# Service Bulletin

Bulletin No.: 17-NA-367

**Subject: High Efforts Required to Press Steering Wheel Pad to Sound Horn**

Brand:	Model:	Model Year:		VIN:		Engine:	Transmission:
		from	to	from	to		
GMC	Acadia Denali (VIN N)	2017	2017			All	All

4868200

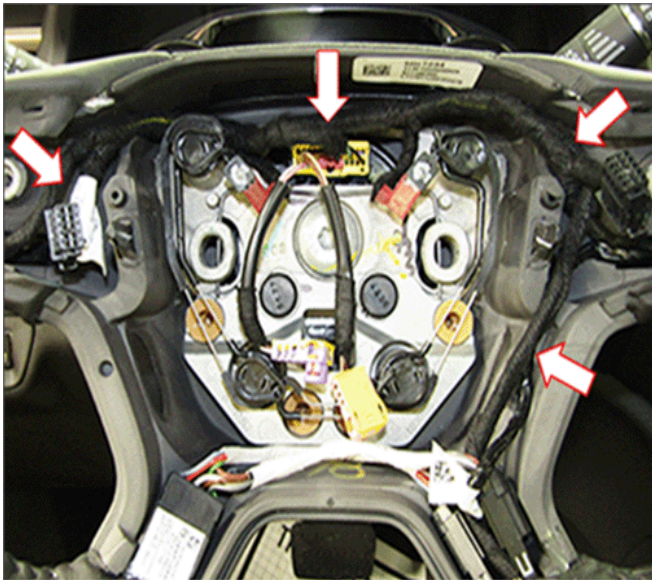
1. Remove the steering wheel airbag and steering wheel spoke cover (1). Refer to *Steering Wheel Spoke Cover Replacement* in SI.

4868201

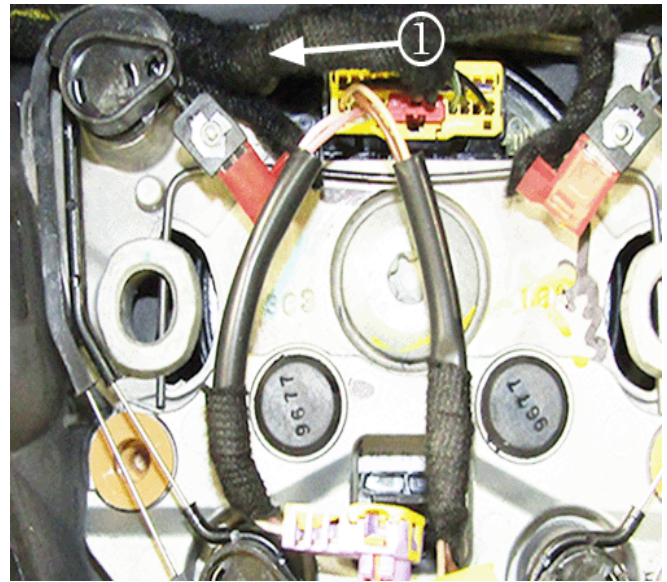
2. Before removing, note the routing and connector locations of the original steering wheel horn switch harness.

4868203

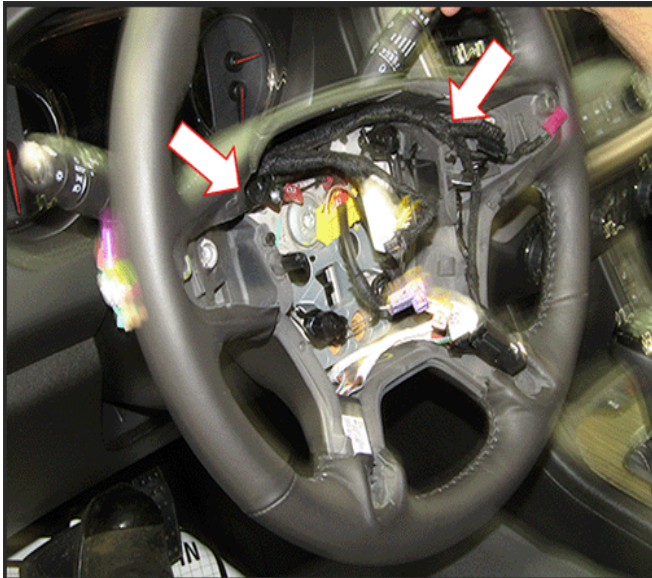
3. Disconnect the connectors, cut the single tie strap (1) near the left, red connector and remove the original harness from the steering wheel.

4868205

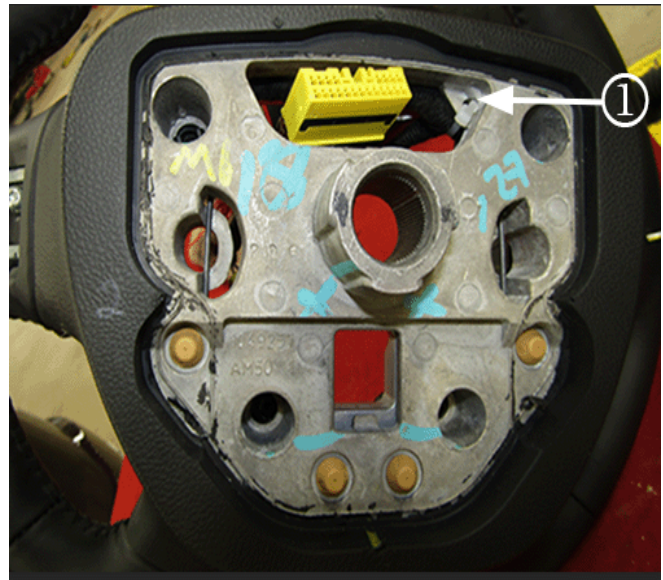
- 4.1. Route the harness across the top of the steering wheel, tucking the harness downward around the upper corners.

4868211

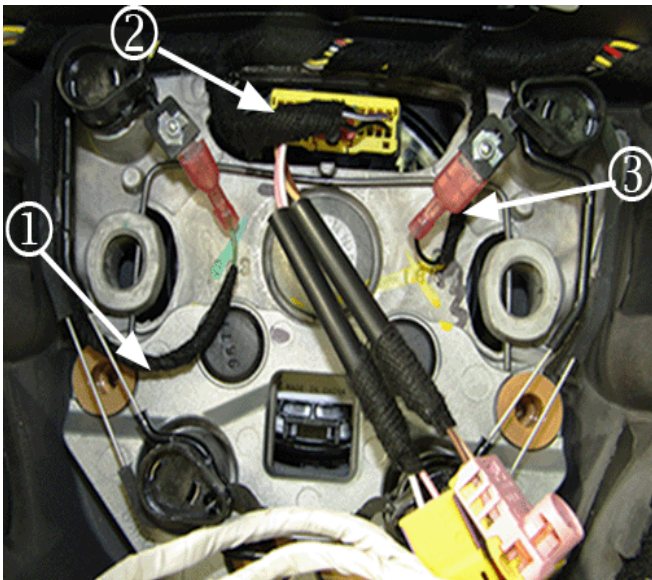
**Tip:** For illustration purposes only, the graphic above shows the location of the tie strap hole (1), from the backside of the steering wheel.

4868207

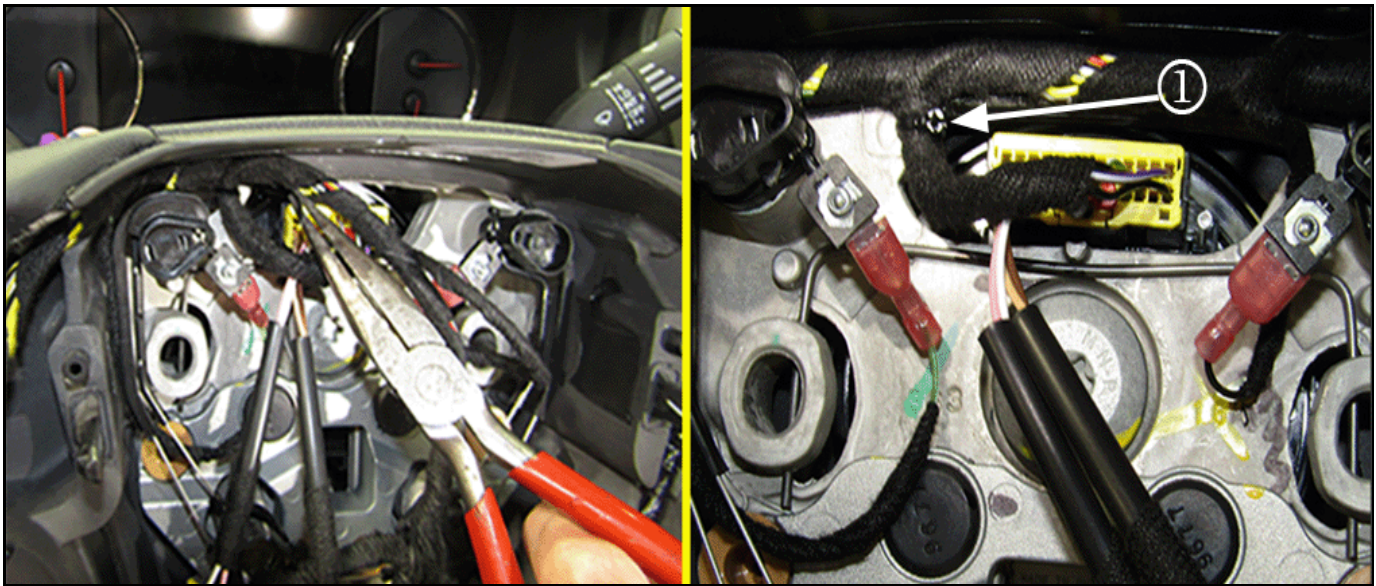
- 4.2. Route the left leg (1) of the red connector under the spring mechanism and back up to the connector.
- 4.3. Connect the larger yellow connector (2) and the right leg of the harness (3) to the red connector.

4868213

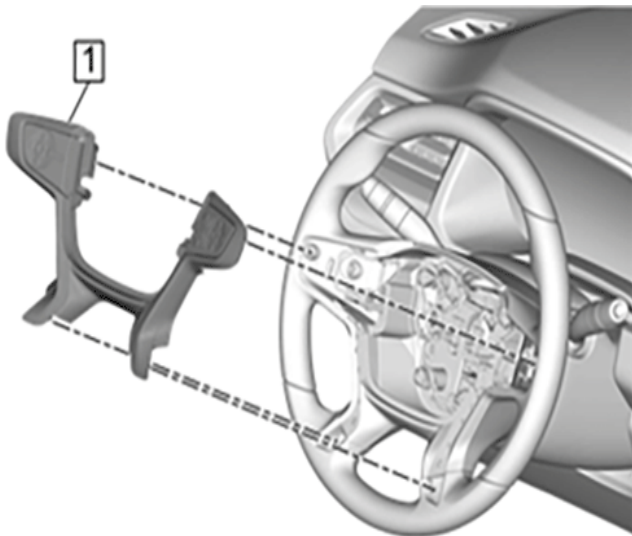
4.4. To help secure the harness across the top, install a tie strap (1) to the downward leg running to the yellow connector. This will help minimize interference of the harness bundle running along the top of the steering wheel.

Leave a slight amount of slack in the right side radio control switch to enable plugging the connector to the switch, after installation of the wheel spoke cover fastener.
